**Re: Toat Café, Stanes Cottage, Stanes Farm and Whitelands Farm, Pulborough RH20 1DN
Planning Application Reference DC/26/0826**

I note the Landscape Consultee, Place Services (PS), raised no landscape objection to our proposals, subject recommendations. However, I note the following in response to comments made in their letter of 21 July 2026. For ease of reference, I note PS quotes in bold italics:

Fig. 2: Extracts from Landscape Strategy by KML.

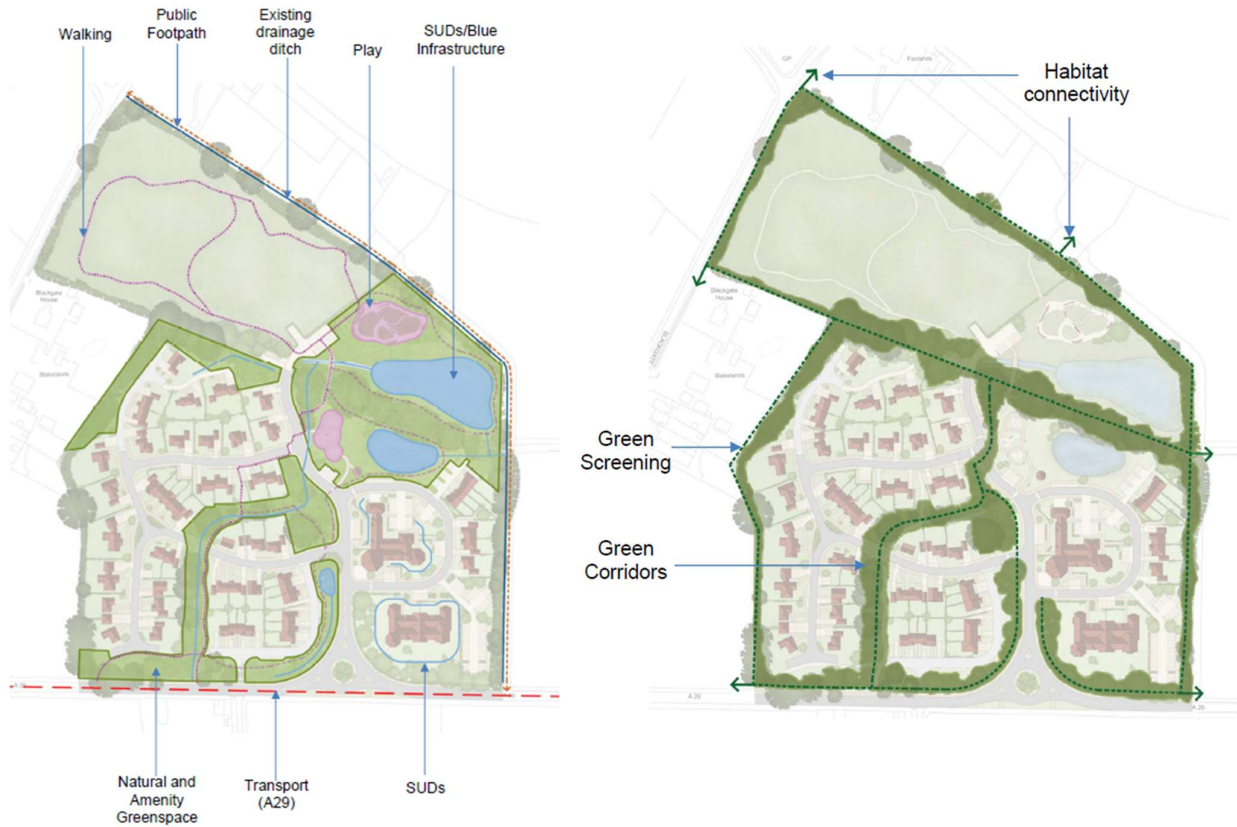
“Greater consideration should be given to delivering multifunctional green corridors as an integral part of the scheme”

The provision of multifunctional green space, including green corridors, is already an integral part of the scheme as demonstrated in the Landscape Strategy by Kevin Murphy Landscape and Garden Design (KML). The extract below shows the extensive natural and amenity greenspace including green corridors which run throughout the site.

Fig 5. Extract from existing site plan with area of hardstanding and road hatched grey

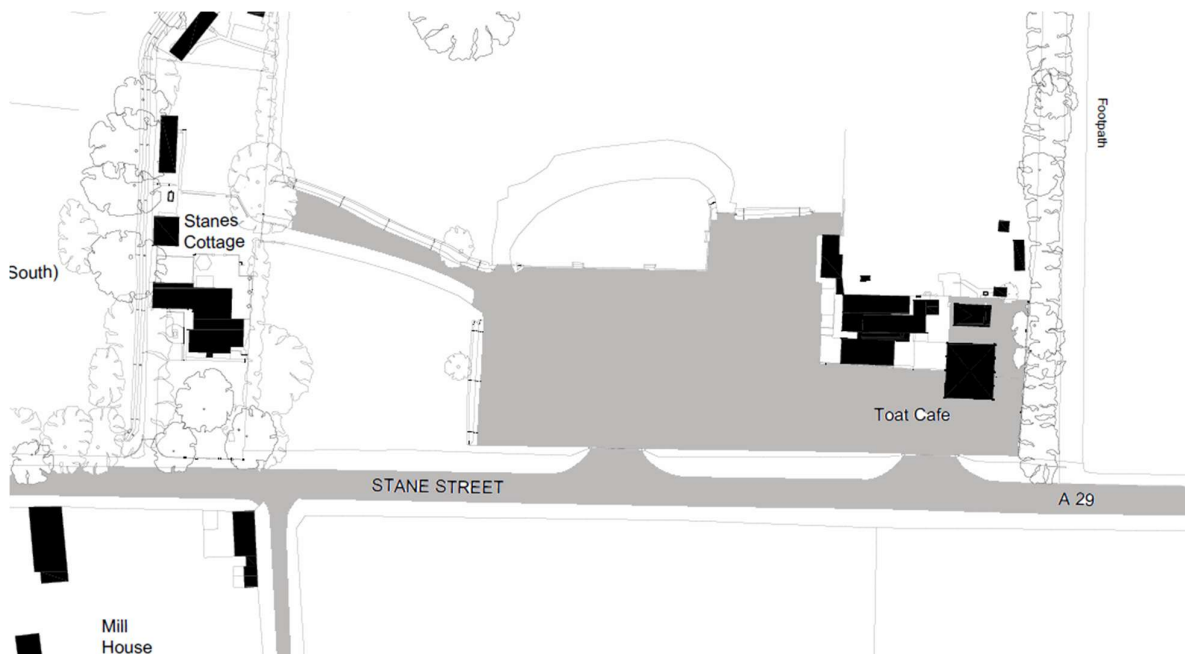
“The introduction of a roundabout would add further urbanising features to the site frontage, contributing to a more urban character in combination with the other existing detracting elements in the surrounding area. Consequently, it is difficult to envisage how the semi-urban frontage character...would be retained under the proposed access arrangement”

We contest this on the basis the existing hard standing is significantly larger than the proposed roundabout as demonstrated in the existing site plan extract below. The proposed tree screening will further enhance the setting in this location.
